Subject: WATER LEAK AT FRONT OF CONVERTIBLE TOP	Bulletin No: 09-013/06
	Last Issued: 4/20/2006

APPLICABLE MODEL(S)/VINS

2006 MX-5 with VINs lower than JM1 NC**** ** 113573 (produced before February 1, 2006)

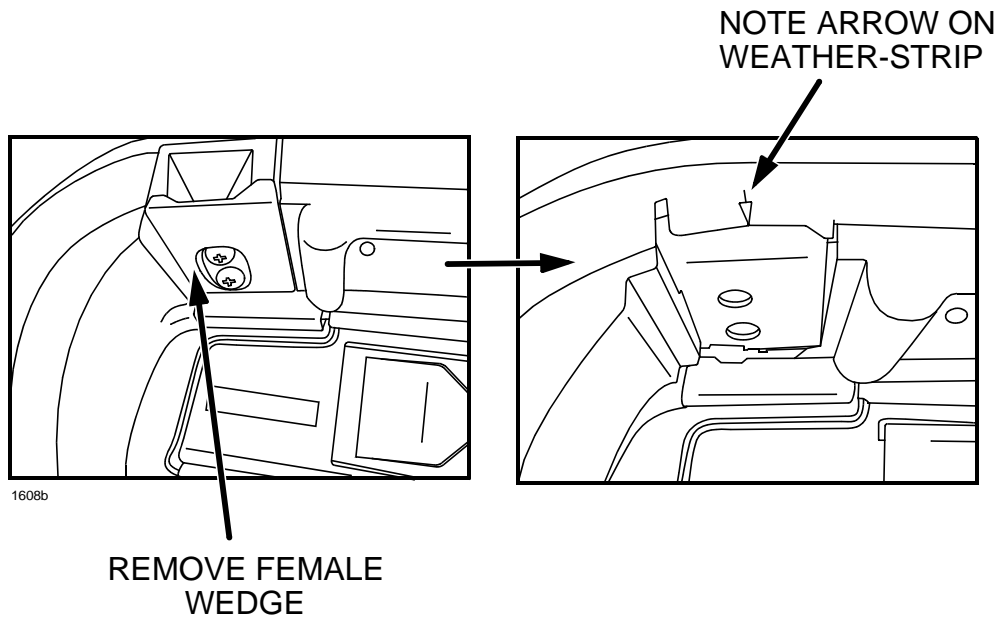
1. Verify customer concern.
2. Remove the female wedge from the side where the water leakage occurs.

1608c

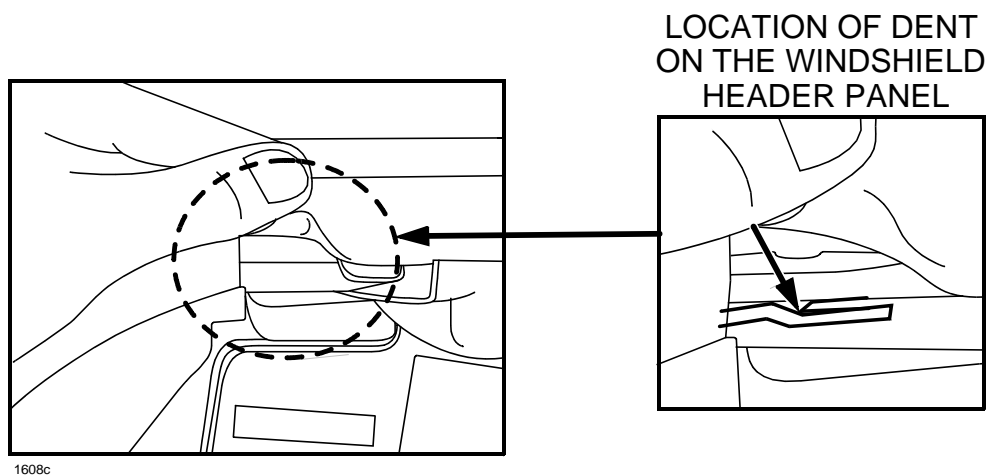
3. Roll up the lip of the weather-strip and confirm there is an indentation (dent) in the windshield header panel.

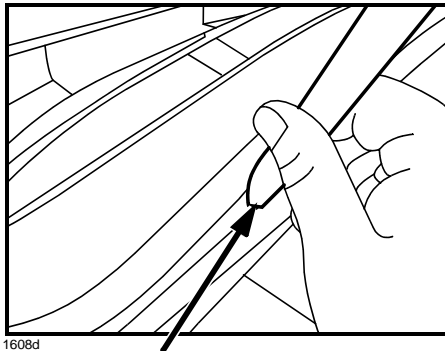
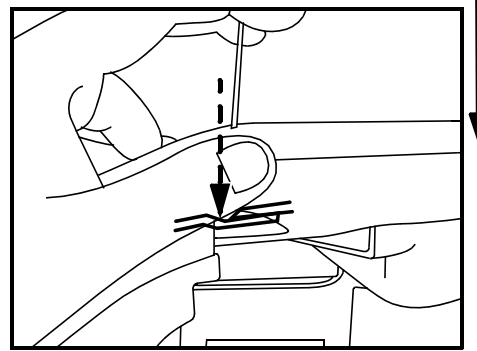
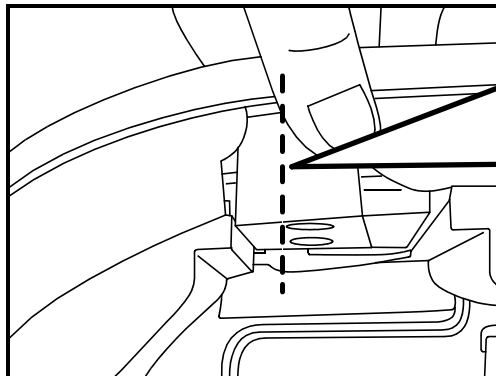
4. Press on the weather-strip at the dent area as shown using a Plastic Windshield Setting Tool (Part Number IS742 - available from Equalizer at 800-334-1334) or similar available through a local supplier.

PRESS THE WEATHER-STRIP AT THE AREA USING A PLASTIC WINDSHIELD SETTING TOOL OR EQUIVALENT

PRESS IN THIS DIRECTION

PRESS AT THIS POINT

1608e

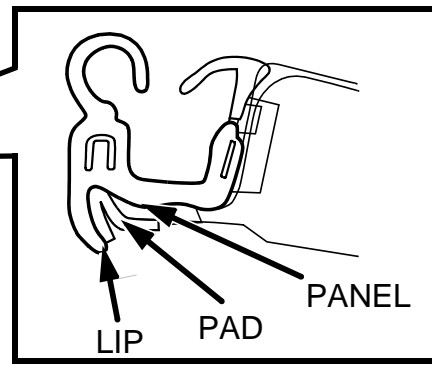
5. Roll up the lip of the weather-strip and insert the foam pad on the back side of the weather-strip as shown.

(CROSS-SECTION)

1608F

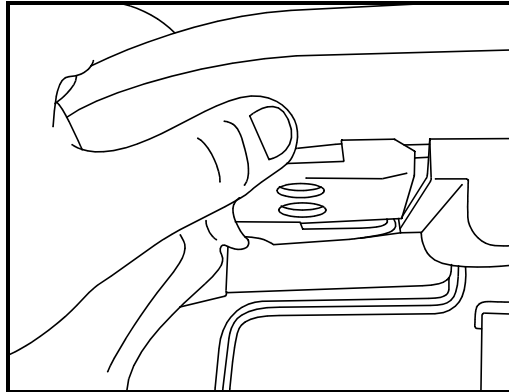
6. After attaching the foam pad, firmly press the weather-strip down where the foam pad was installed.

**FIRMLY PRESS THE WEATHER-STRIP
 OVER THE PAD**
